ASM FACILITY SITE PLAN

SP# 13-22 (FOLLOW UP TO MSP# 03-22)

STAFF REPORT

October 26, 2022

SITE PLAN
MAP 2 / LOT 14-8
NASHUA FABRICATION CORP.
SECURITY DRIVE
HUDSON, NEW HAMPSHIRE

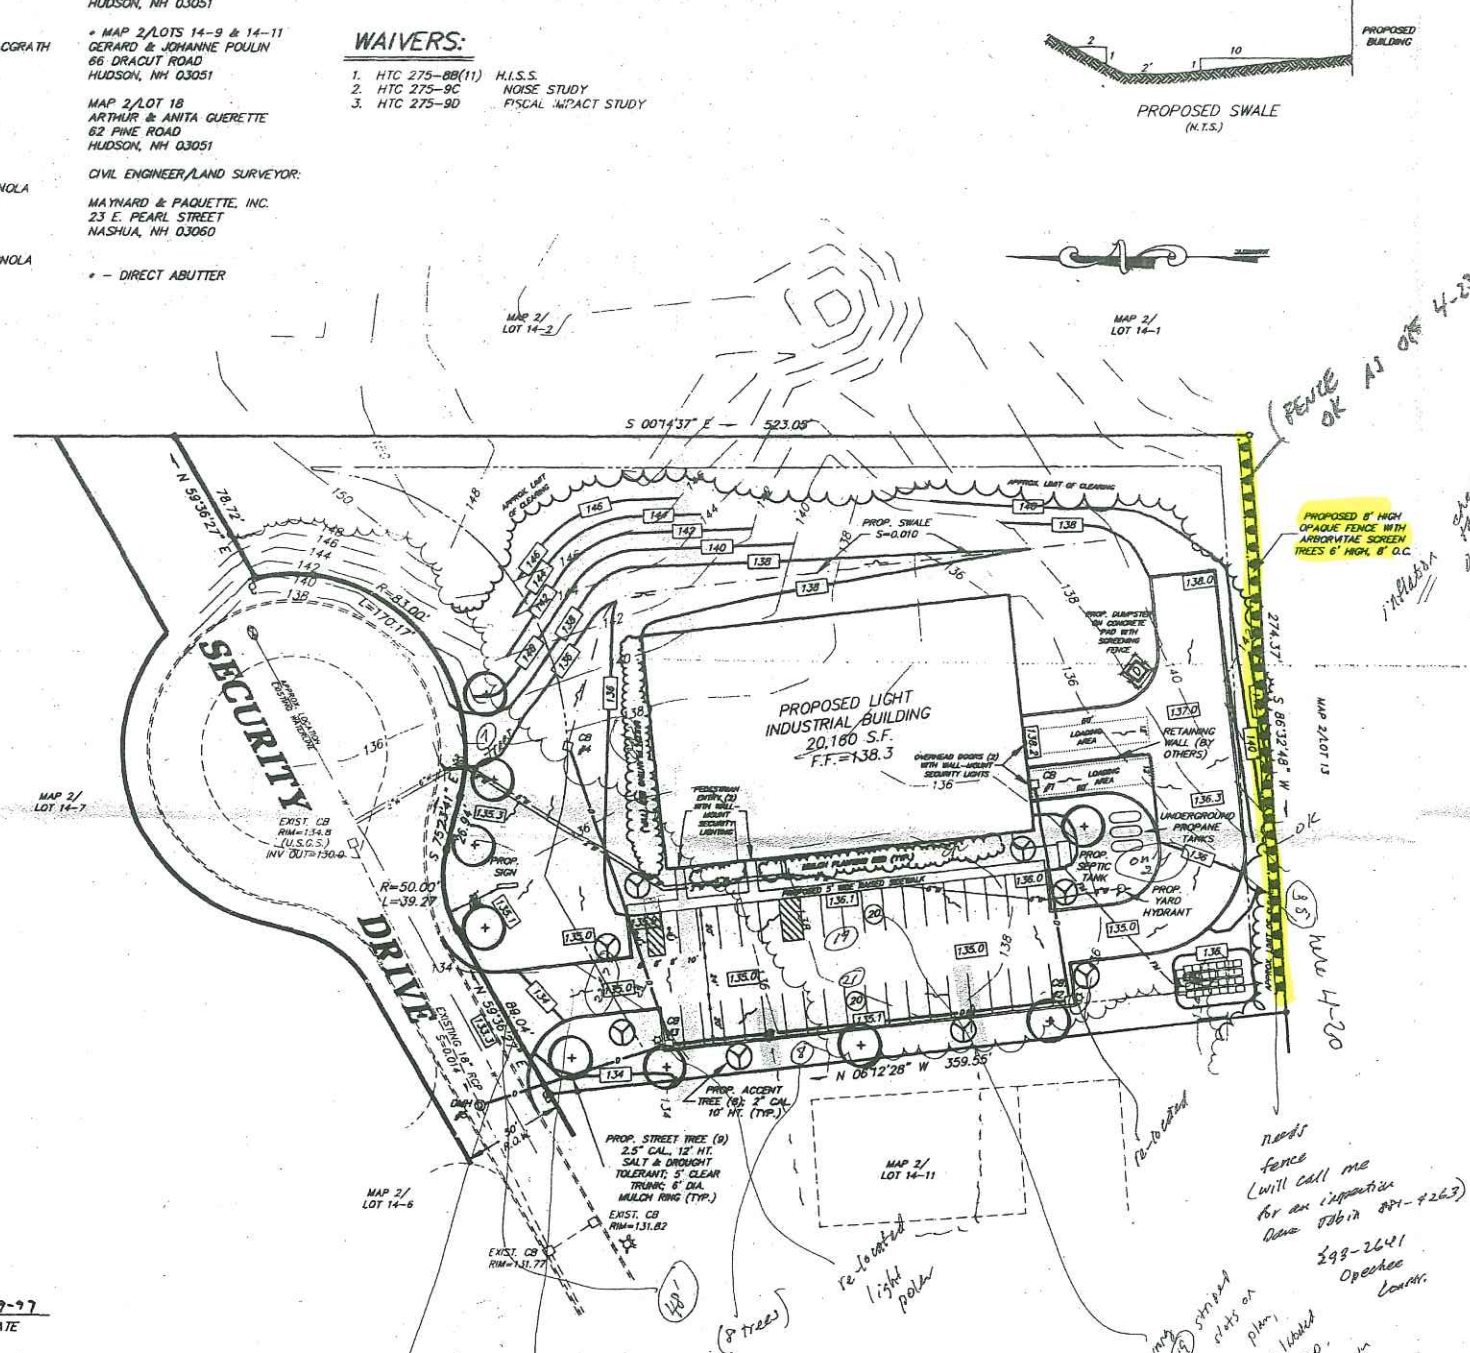
I would recommend adherence to the original site plan of 1997 HCRD # 28977 and have the fence and tree buffer along the southerly property line installed/completed as approved on that 1997 plan.

9. Applicant shall provide soil testing results for the pervious pavement area prior to recording the plan.
10. The site plan shall be revised to include the full extension of the stockade fence and planting of arborvitaes in accordance with the previously approved site plan, HCRD #28977.

NO.	DATE	DESCRIPTION	BY
PROJECT NO.	718770		
CADD FILE	718770_C101		
DESIGNED BY	MSK		
DRAWN BY	MSK		
CHECKED BY	SMB		
DATE	9/13/2022		
DRAWING SCALE	1" = 30'		
GRAPHIC SCALE			
SHEET TITLE			
SITE PLAN			
DRAWING NO.			C101
4 OF 13

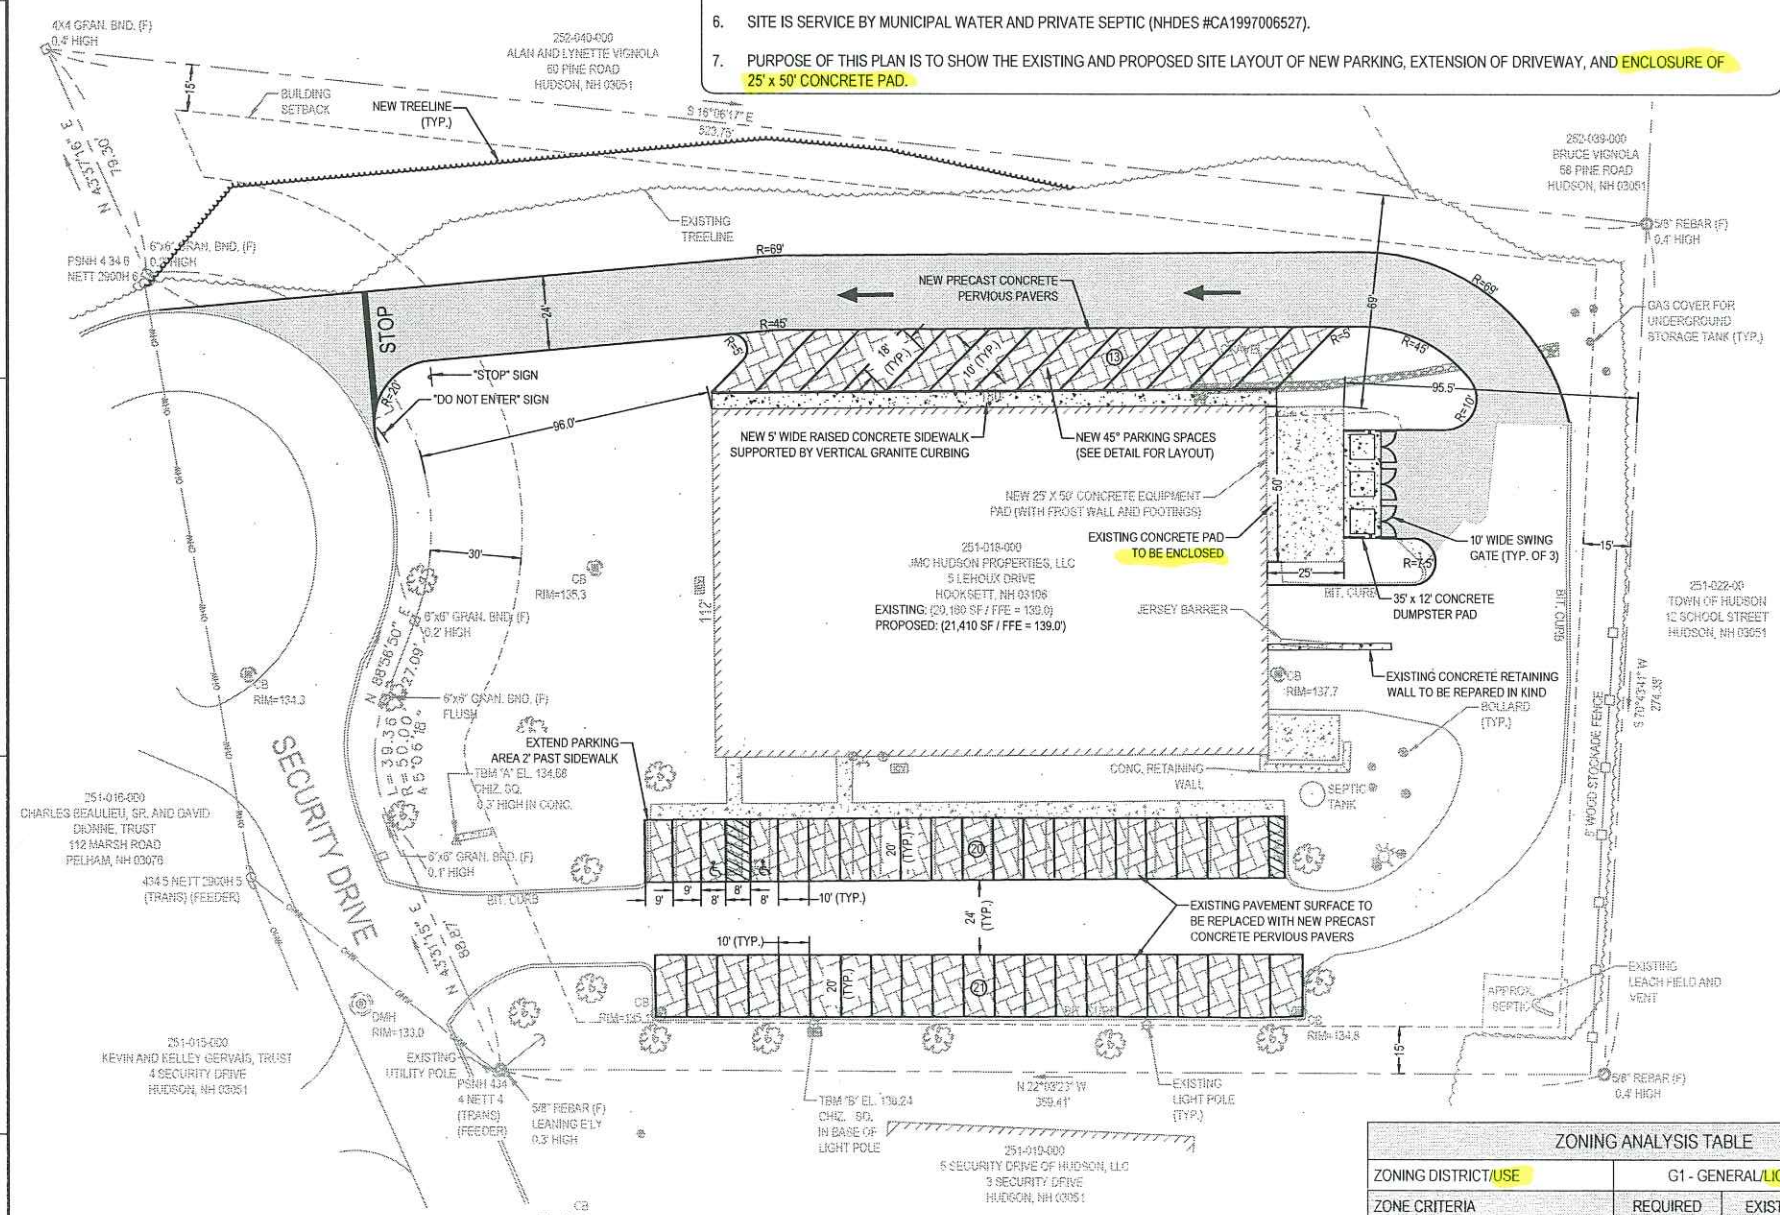
While much of the industrial development exists today, the expansion of the improved part of the industrial development is increasing in proximity to a residential use. Per §276-11.1.B(12)(a), a 200-foot distance is required from the residential property line to any improved part of the industrial development. The proposed design requires a waiver from this provision.

The application proposes an additional driveway curb cut, requiring a waiver from §193-10.G that permits only one.

1. Engineering: Applicant shall provide a maintenance/cleaning schedule and plan for the pervious pavement, and applicant shall provide soil testing results prior to installing the pervious pavement.
2. Zoning: Applicant should identify the “light industrial” uses with the Table of Permitted Principal Uses §334-21 and should specify if the enclosure has a roof, and if so, its height. Also, there has been a recent Code Enforcement complaint about outdoor fabrication operations, potentially in violation of §249 Noise and possible §334-16.1 Site Plan. Zoning recommends that the applicant should have the fence and tree buffer along the southerly property line installed/completed as approved in the original 1997 site plan.

7. Hours of refuse removal shall be exclusive to the hours between 7:00 A.M. and 7:00 P.M., Monday through Friday only.
8. Applicant shall provide a maintenance schedule and plan for the pervious pavement prior to construction.
